LA Department of Building and Safety  
LA 04 17 149582 03/07/05 04:15PM

T-24 and emergency lighting plan check for remodeled restaurant. REWIRE.  
CEQA CATEGORICAL EXEMPTION CLASS 31.

## PLAN CHECK LIST

Plan Check No.	05041 10000 08420	Plan Check Expiration Date
Job Address:	127 E 9th STREET.	
Square Footage	Use Zone	Fire Zone
Occ. Group	Type of Construction	No. of Stories
Applicant	ALEX GARCIA	Phone 626 216 6809 Fax
Reviewed by	GEORG CHEATHAM	Date 05/03/2005 Telephone 213 482 0062
2 <sup>nd</sup> Review by	GEORG CHEATHAM	Date 06/06/2005 Telephone

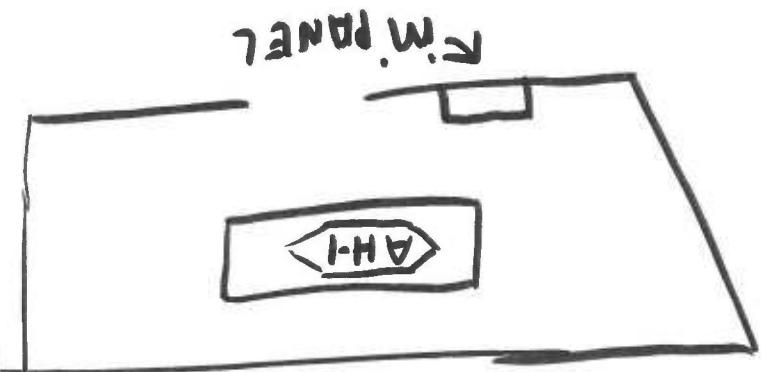
SHOW "MSB" ENTIRE SECTION

⑥

⑤

→ SHOW LOCATION IN MEASURE.
